III. Single/Multiple Element Tripping with Protection Violation

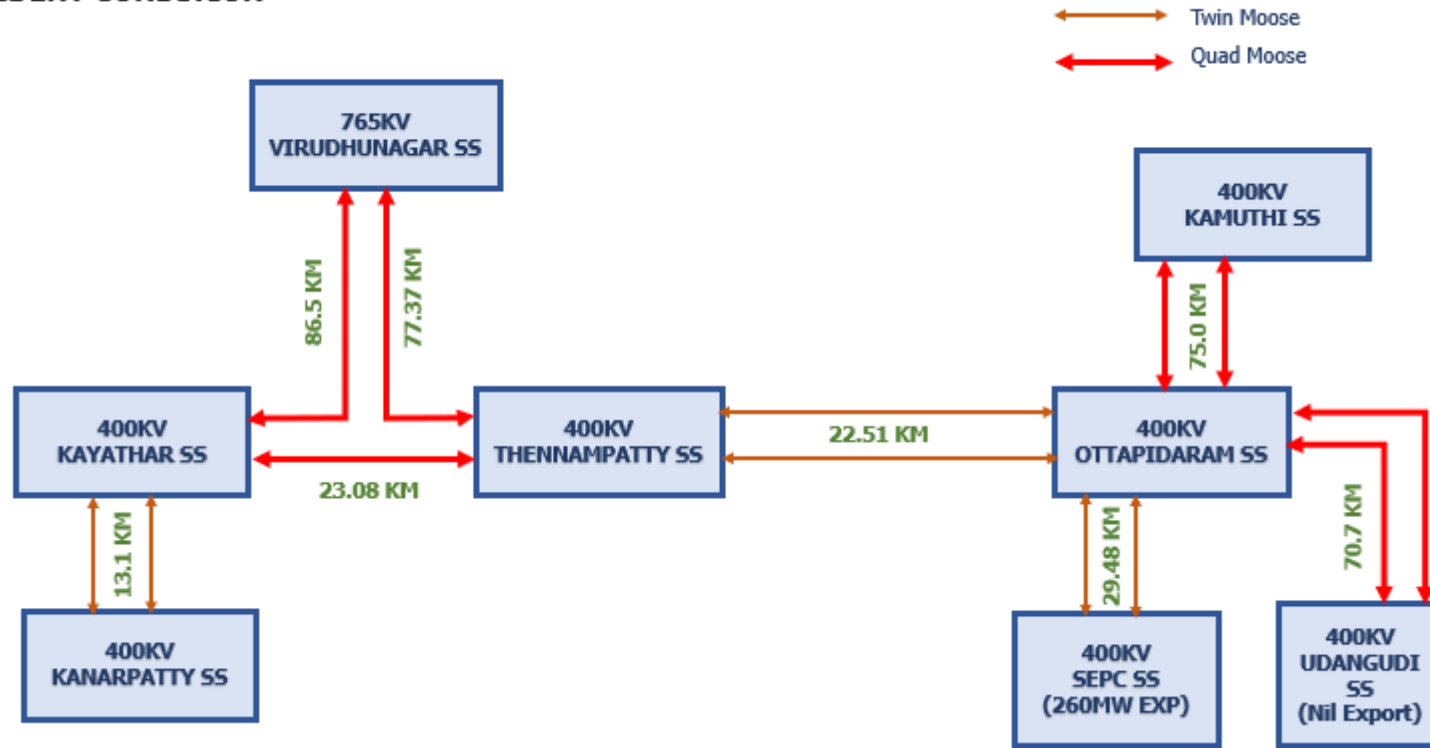
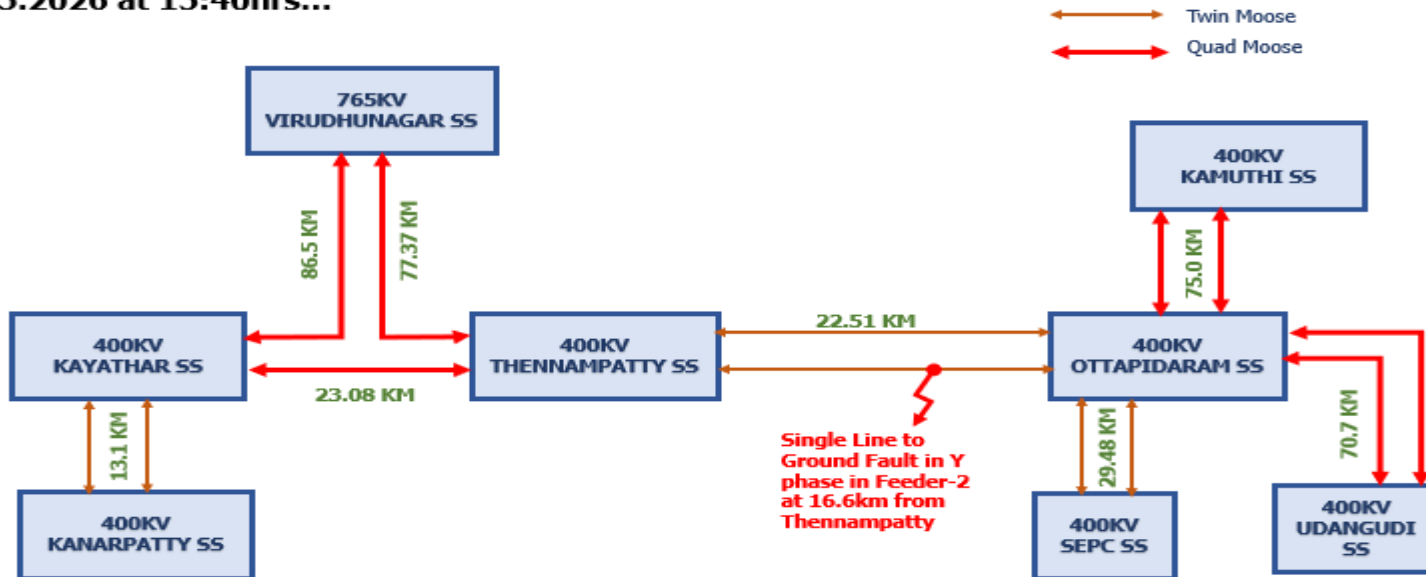
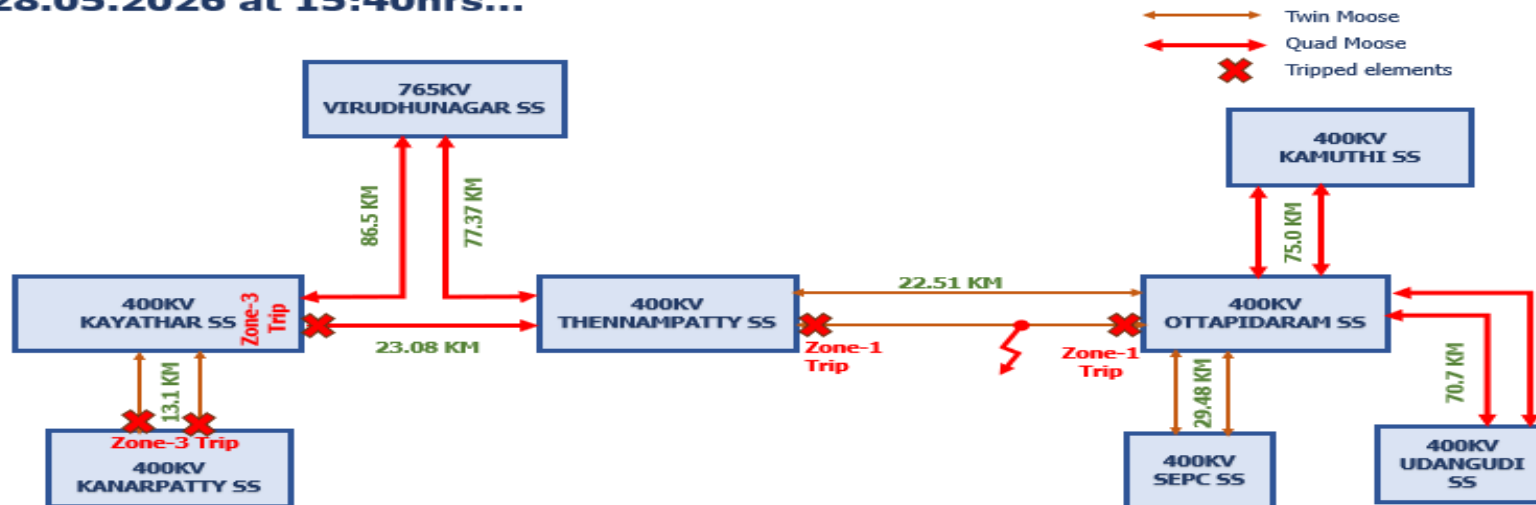
4. TANTRANSCO informed that Single Line to Ground fault in Y phase (Location – 16km from Thenampatty) on 28.05.2026 at 15.40 hrs.
5. At 400KV Thenampatty end:

- TANTRANSCO informed that, on analysis of the disturbance recorder (DR), both Main-1 and Main-2 relays detected the fault within Zone-1 in the Y-phase and issued a single-pole trip command to the Y-phase breaker.

- TANTRANSCO further informed that the DR recorded a fault current of 8.1 kA in the Y-phase along with a significant dip in the Y-phase-to-neutral voltage to 75 kV (33%). However, despite the Y-phase trip command being issued by the relays, the R-phase breaker pole was found to have opened, as indicated by the reduction of the R-phase-to-neutral voltage to zero, while the fault current in the Y-phase continued to persist.

- TANTRANSCO further informed that, due to the inadvertent opening of the R-phase pole, the R-phase-to-neutral voltage collapsed to zero. Since there was no source contribution from the remote end, the measured R-phase voltage remained zero while the fault current in the Y-phase continued to persist.

- TANTRANSCO further informed that, due to the voltage dip in both the R and Y phases, the polarization voltage required for impedance computation and phase selection was unavailable. Consequently, the Zone-1 trip elements in both Main-1 and Main-2 relays dropped out immediately, within 100 ms of the fault, following the opening of the R-phase breaker.

- TANTRANSCO further informed that the fault current persisted beyond the Zone-3 time setting of 800 ms, due to which the corresponding protection elements at the 400 kV Kayathar and 400 kV Kanarpatty substations operated under Zone-3 protection.

- TANTRANSCO stated that, although the fault location was within the Zone-3 reach of the 400 kV Ottapidaram–Thennampatty Line-1, Zone-3 protection did not operate at the Ottapidaram end, possibly due to weak source conditions, as only the 400 kV Kamuthi substation was available as the source. TANTRANSCO further informed that there was no generation from Udangudi and that the generating transformer at the SEPC end had tripped.

- TANTRANSCO stated that the Zone-3 reach setting at the Ottapidaram end would be verified for the 400 kV Ottapidaram–Thennampatty Line-1 feeder.

11. Remedial action taken by TANTRANSCO at 400kV Thenampatty SS

- At THENNAMPATTY SS, the breaker & relays in 400kV Ottapidaram-2 were tested on 29.05.2026.
- It was observed that in the 400kV Breaker Marshalling box, the R & Y phase cables (both tripping & status wires) were

interchanged due to ferruling mix up.

- The wiring was set right, the breaker single pole trip from both Main-1 & Main-2 relays were checked and operation of the correct breaker pole for each trip was ensured.
- The operation of Auto-reclosure & LBB functions was also tested and found to be in order.

12. SRPC advised TANTRANSCO to submit the detailed analysis report on the non-operation of single-pole tripping and auto-reclosure in the 400 kV Ottapidaram–Thennampatty Line-1 feeder.

13. SRPC advised TANTRANSCO to verify and confirm the correctness of all control, tripping and status wiring connections in the breaker marshalling boxes of similar bays to avoid recurrence of such incidents.

14. SRPC advised TANTRANSCO to analyse the non-operation of Zone-3 protection at the Ottapidaram end and to review and validate the Zone-3 reach settings of the 400 kV Ottapidaram–Thennampatty Line-1 feeder.

15. SRPC advised TANTRANSCO to investigate the operation and subsequent reset of the directional earth fault (DEF) element at the SEPC generating transformer and submit the analysis report.

16. SRPC further advised TANTRANSCO to carry out a comprehensive review of the protection coordination, breaker wiring schemes, auto-reclosure logic and breaker failure protection associated with the affected feeders and submit the compliance report to SRPC.

TC-1 & 2 Assembly (Faulty)

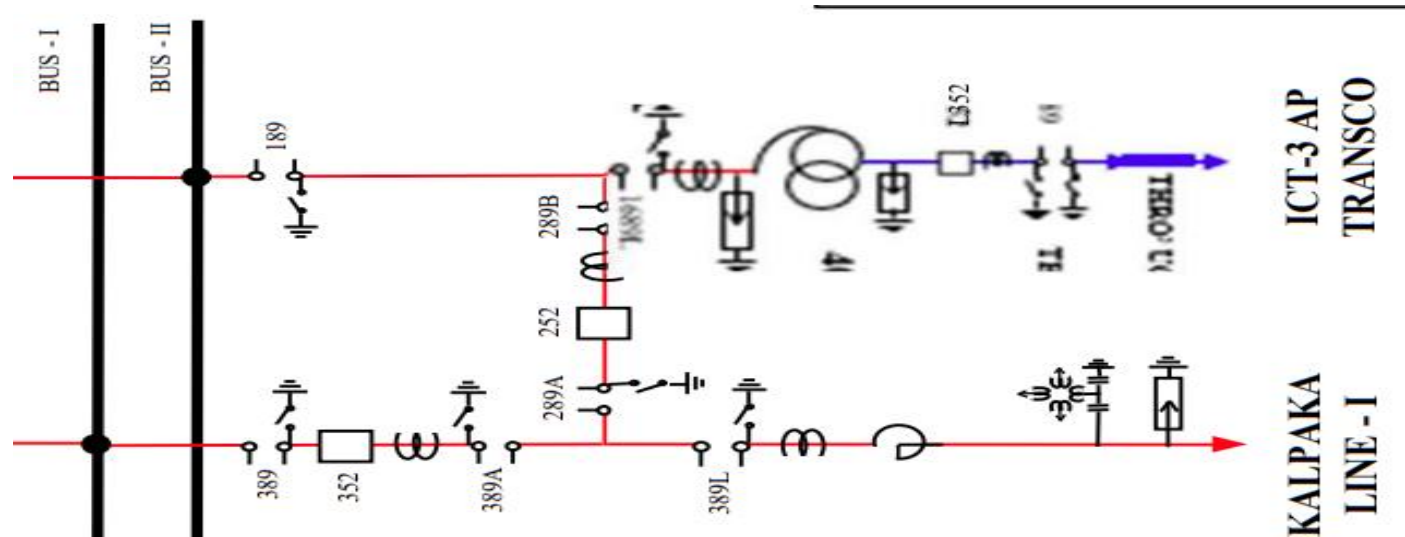
Inadvertent Opening/ Closing of CB poles:

- Trip coil-1 & trip coil-2 in R-Ph also got failed due to which DC mixing has happened.
- Cracks Observed on R Phase Close coil. The coil is found to be earthed.
